CONSTRUCTION PLANS FOR BOYCE PARK ACID MINE DRAINAGE REMEDIATION

RECORD DRAWINGS 10/07/08

**ACID MINE DRAINAGE
REMEDATION
PROJECT NO. ZCBP-AD01**

**ACID MINE DRAINAGE REMEDIATION
BOYCE PARK
OLD FRANKSTOWN ROAD
MONROEVILLE BOROUGH
FILTRATION SYSTEM PIPING
AND ROADWAY DRAINAGE PLAN
PROJECT NO. ZCBP-AD01**

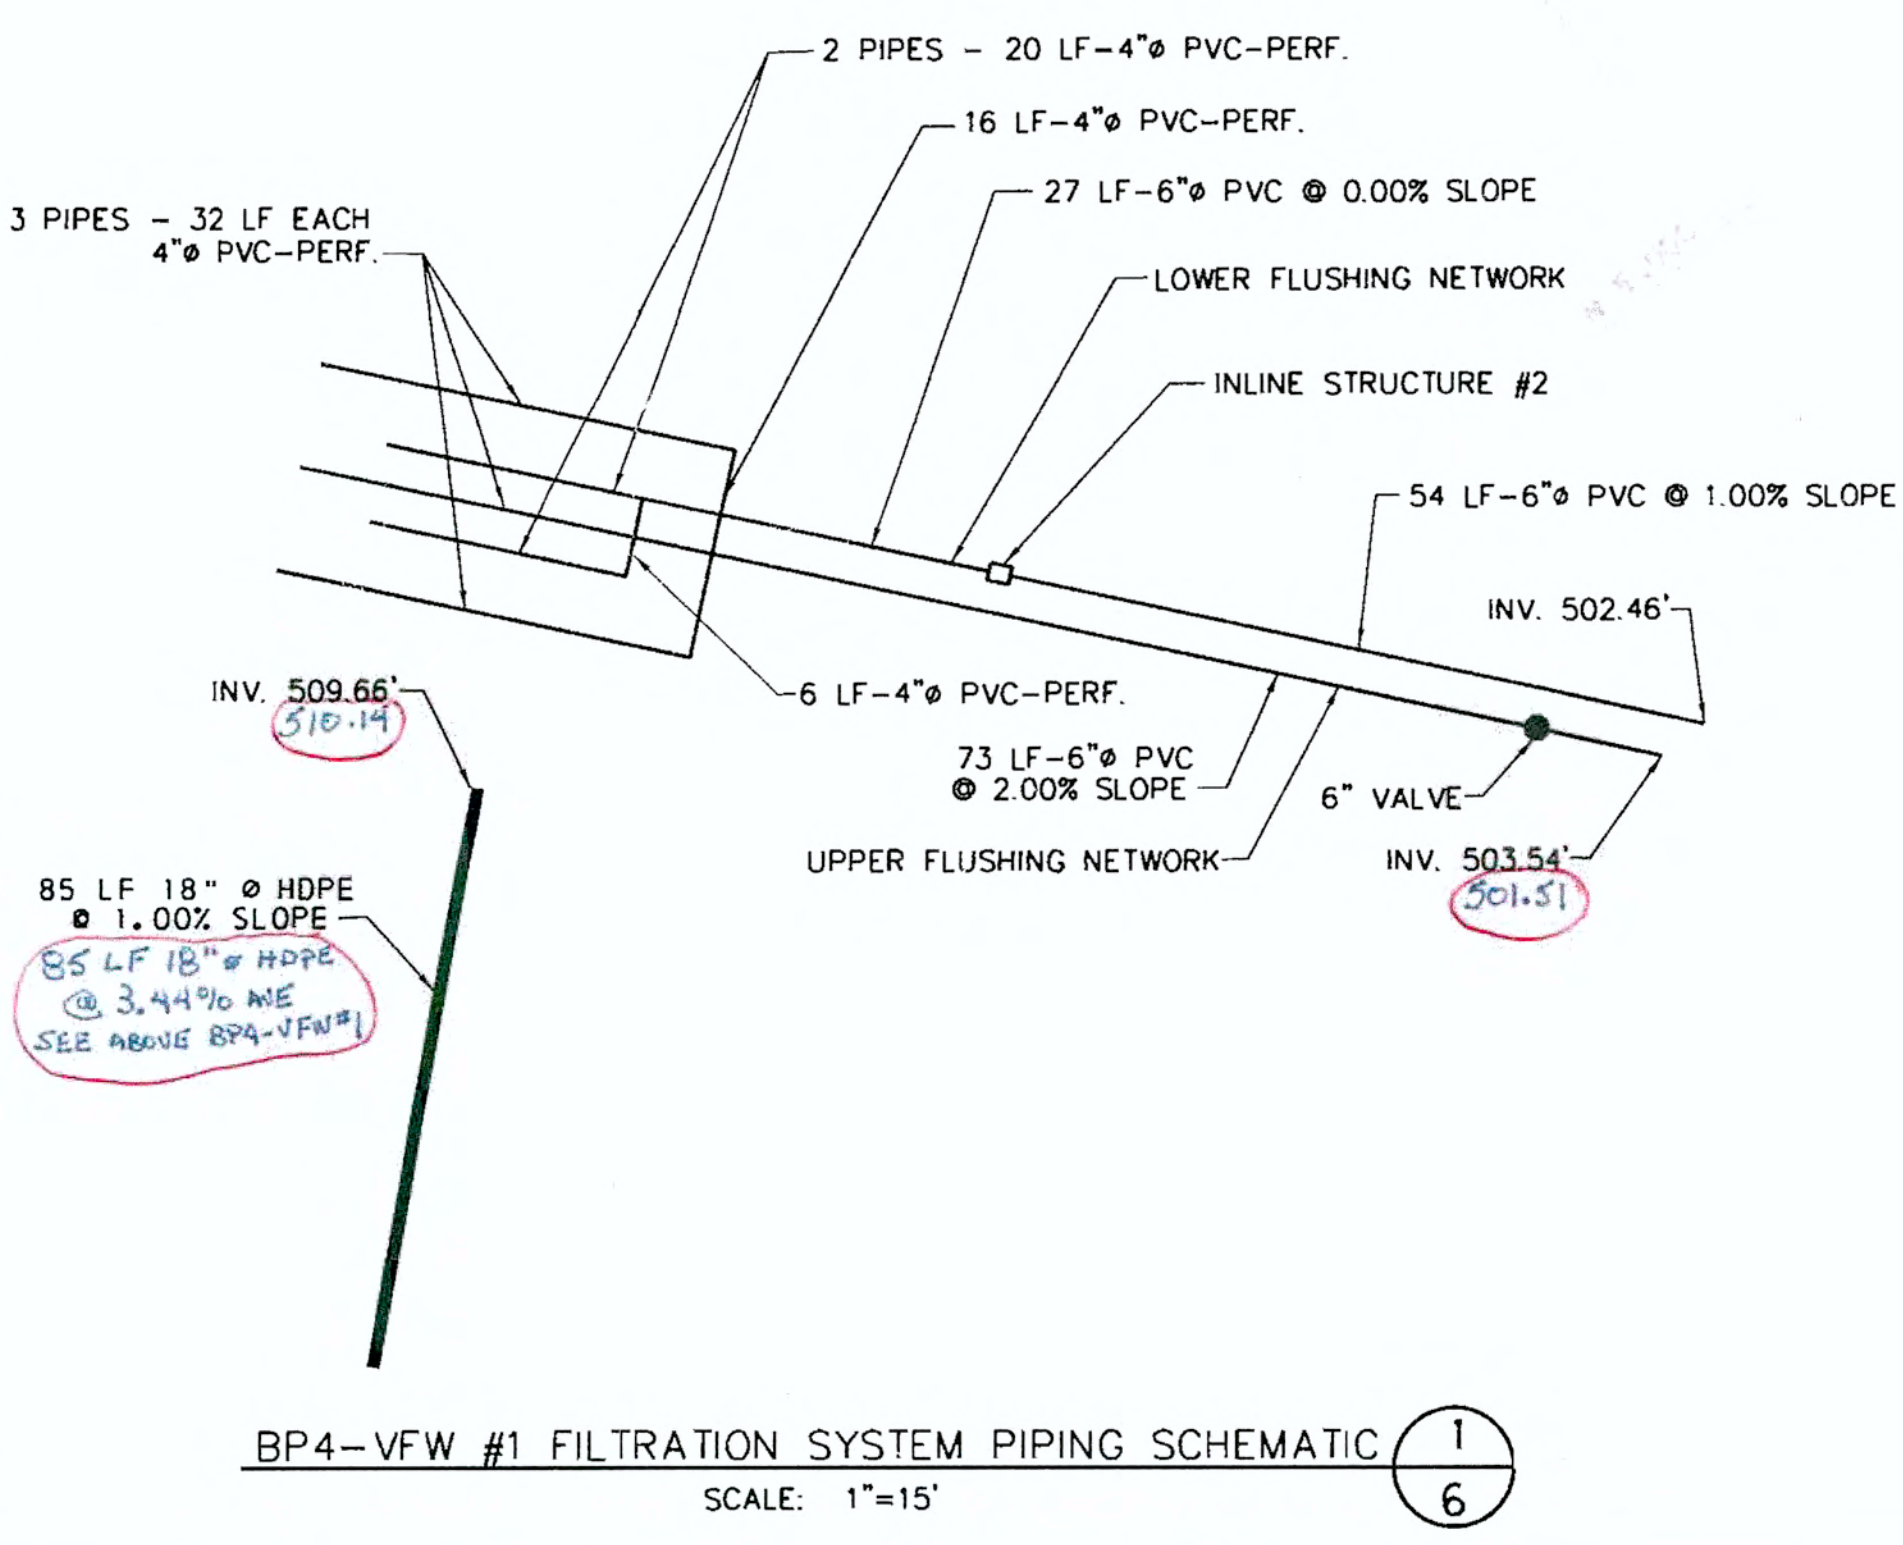
- NOTE:**
- CHAIN LINK FENCE
 - SPLIT RAIL FENCE
 - GAP IN FENCE APPROX 3.50 FT
 - ELEVATION IN WETLAND (ACTUAL) WETLAND BASIN LOWERED 2 FT IN ELEVATION
 - GATE

**ACID MINE DRAINAGE REMEDIATION
BOYCE PARK
OLD FRANKSTOWN ROAD
MONROEVILLE BOROUGH
FILTRATION SYSTEM GRADING
AND PIPING DETAILS - 2
PROJECT NO. ZCBP-AD01**

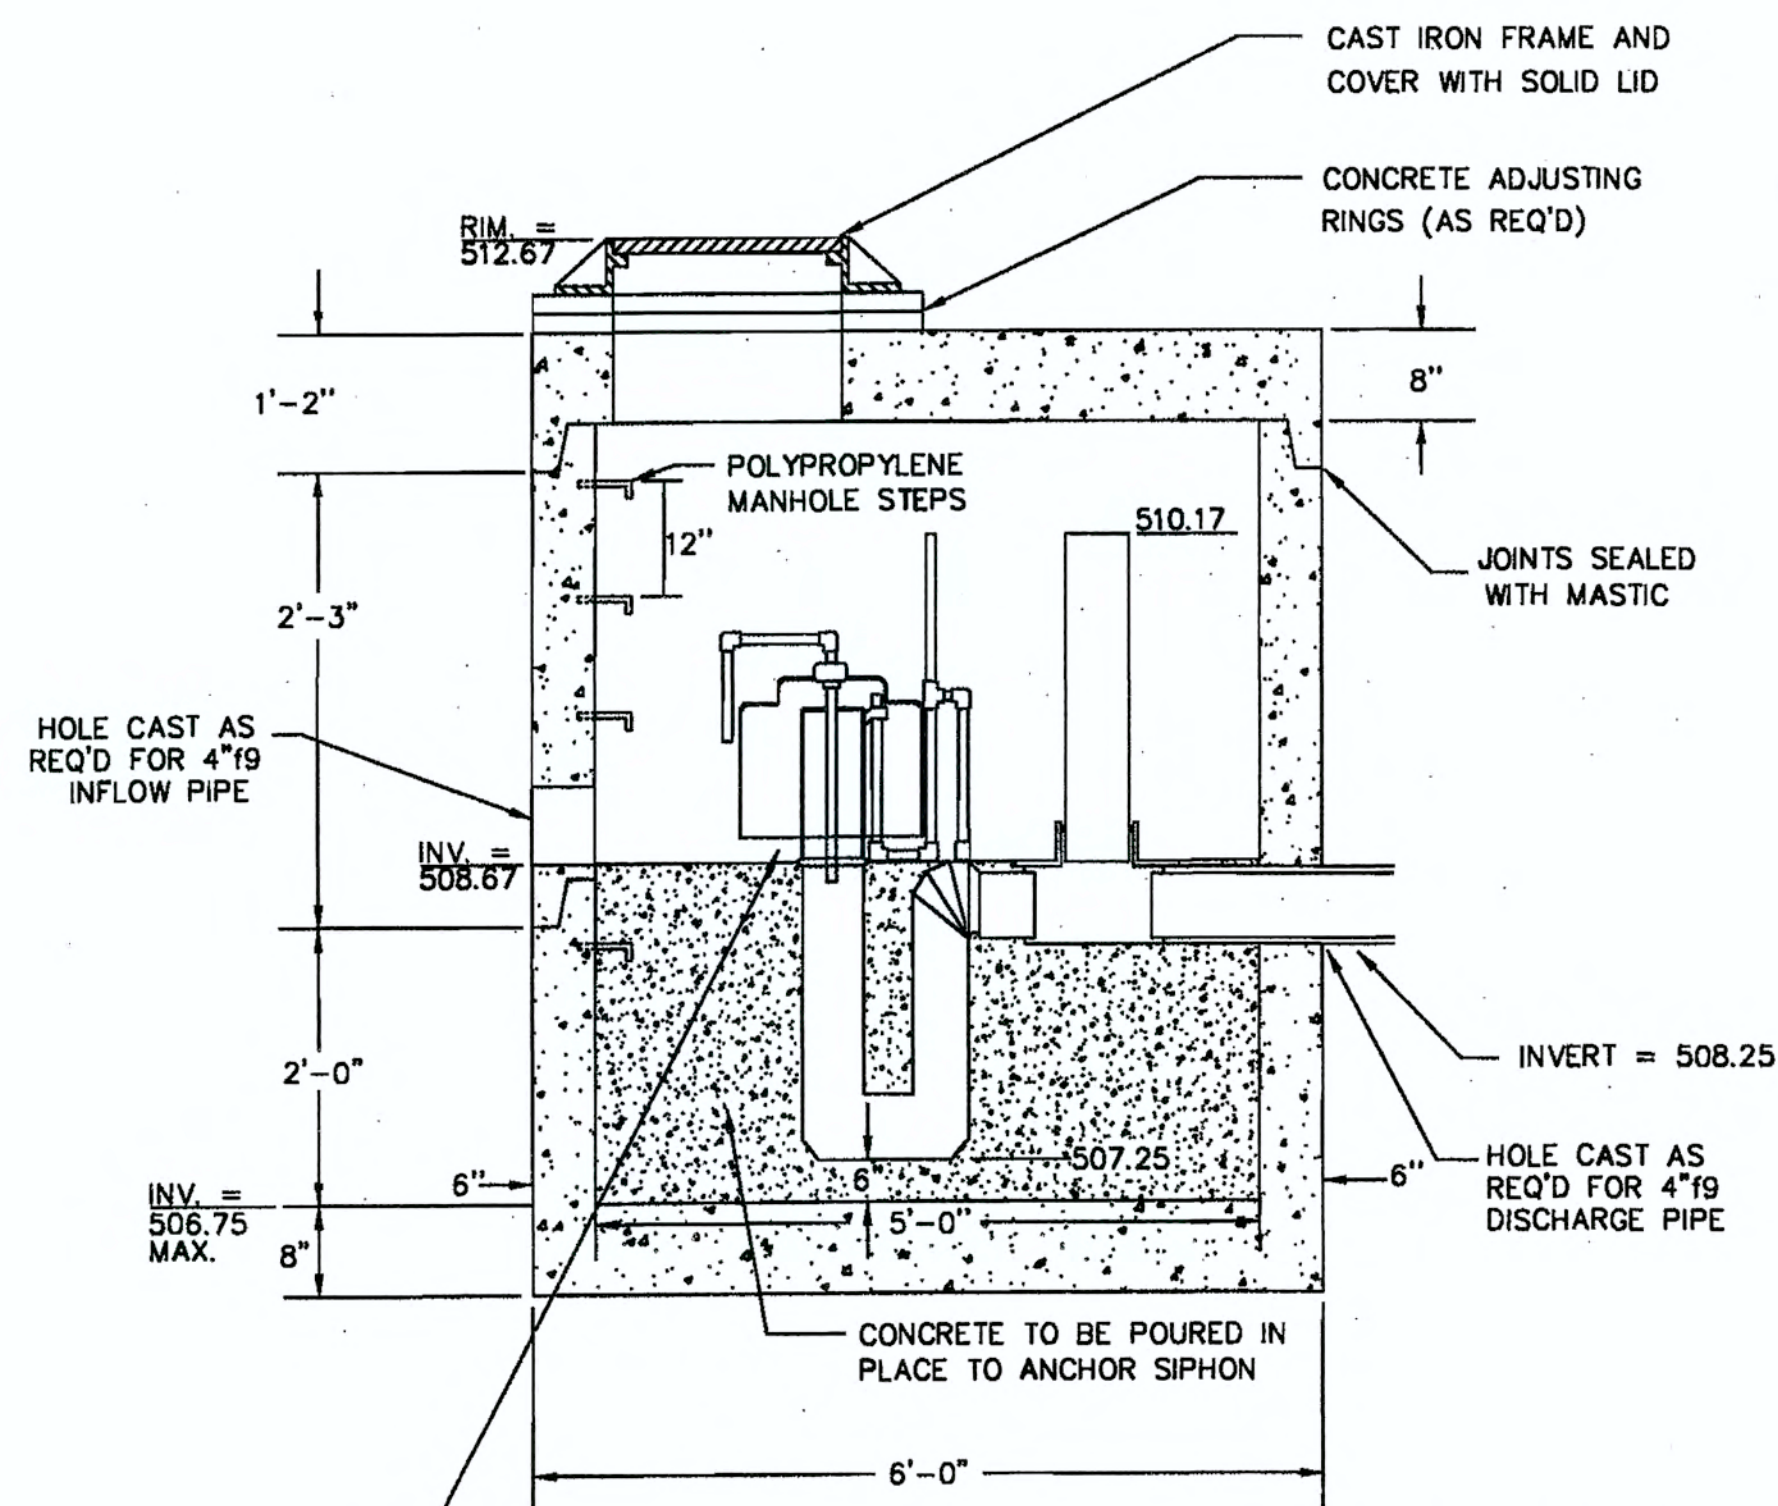
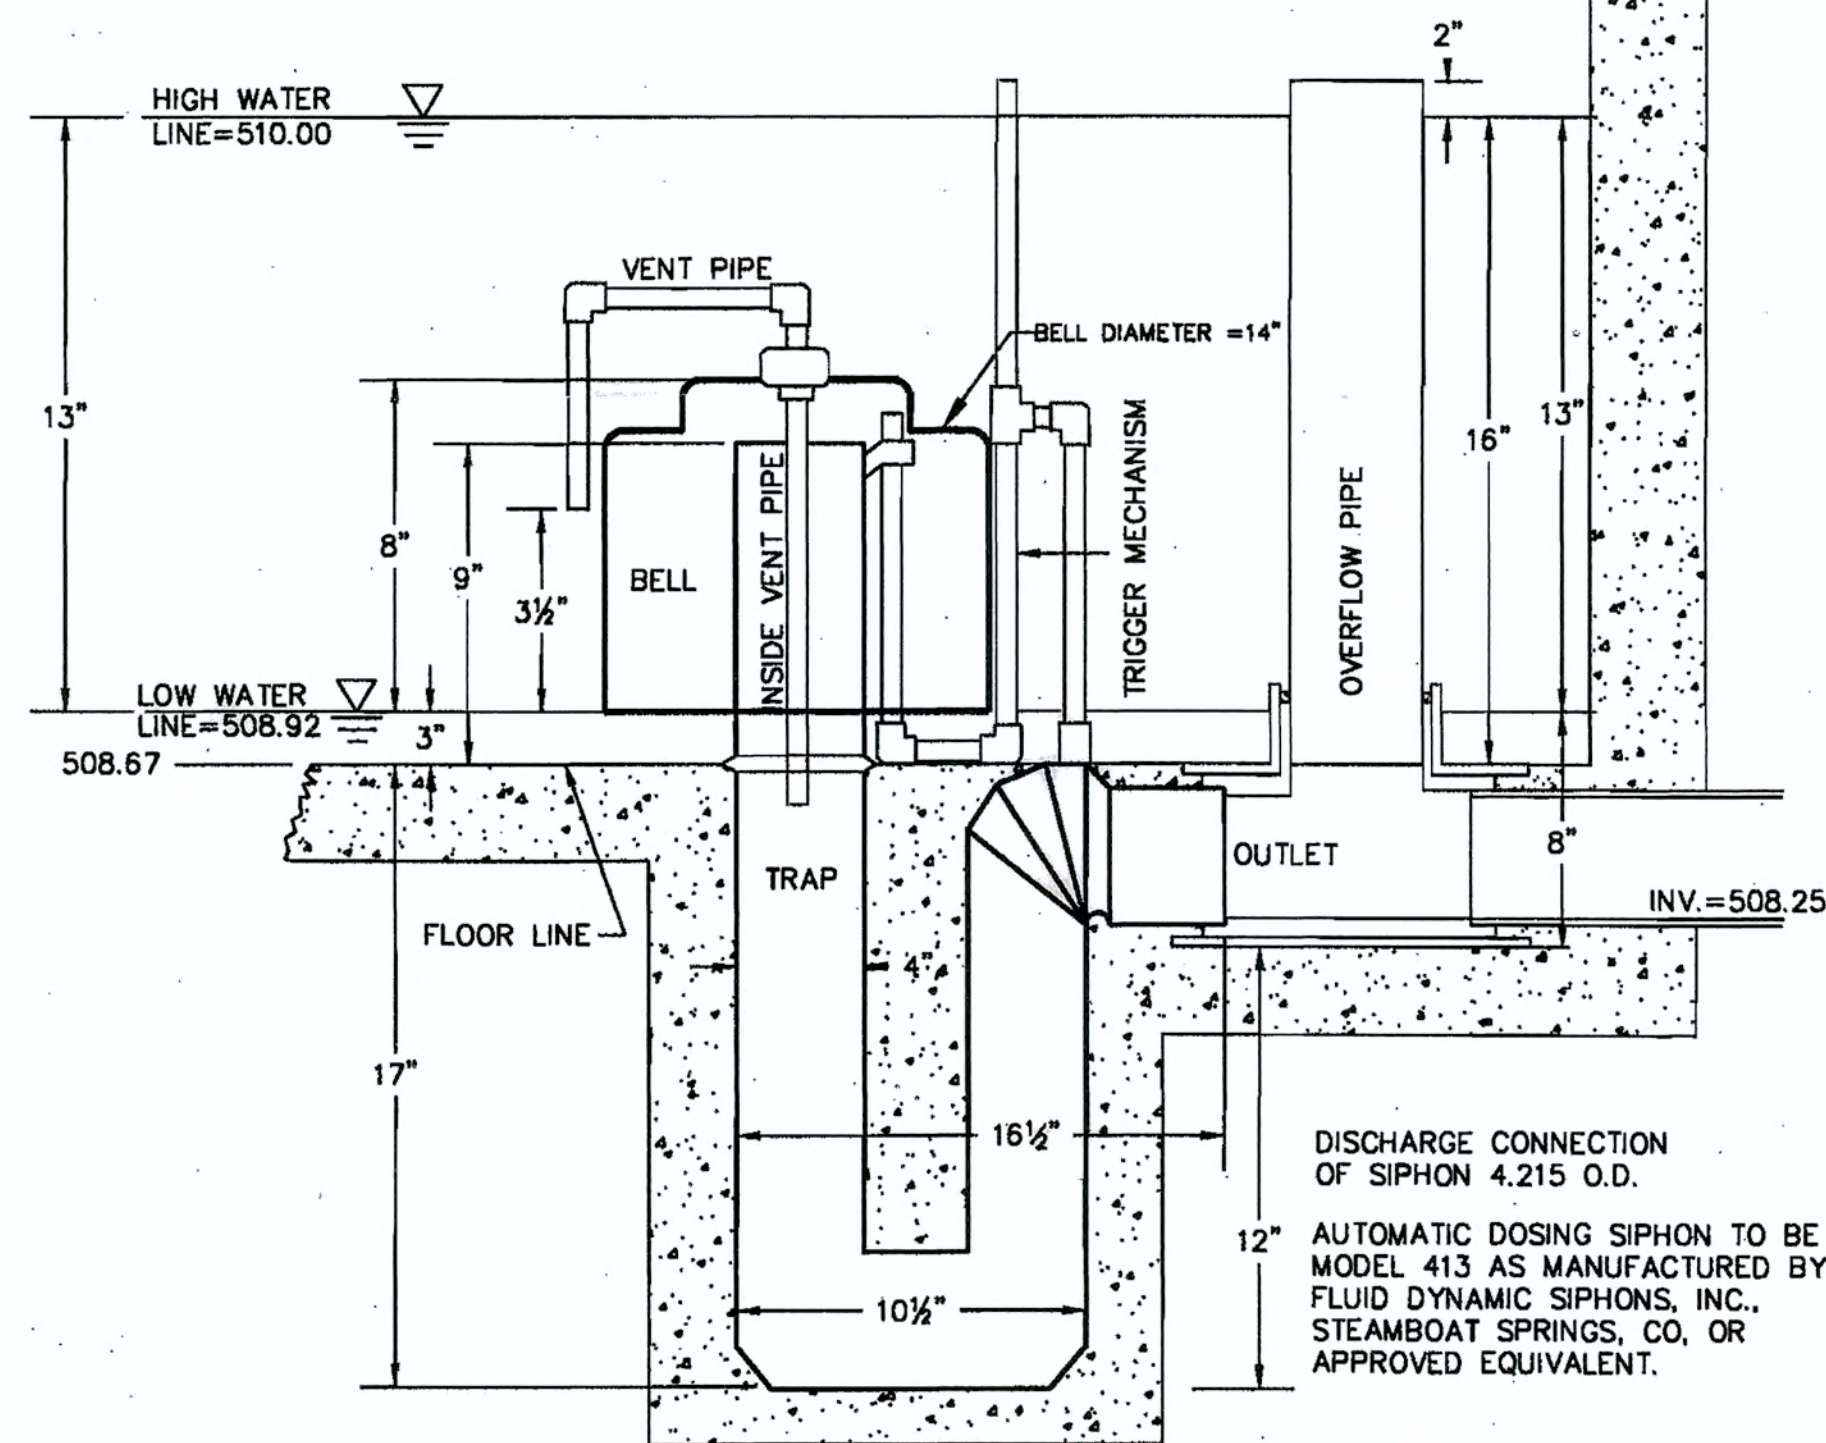
NOTE:
INSTALLED AS PER PLAN
UNLESS NOTED BY #

OK JH 9-12-08
NOTE
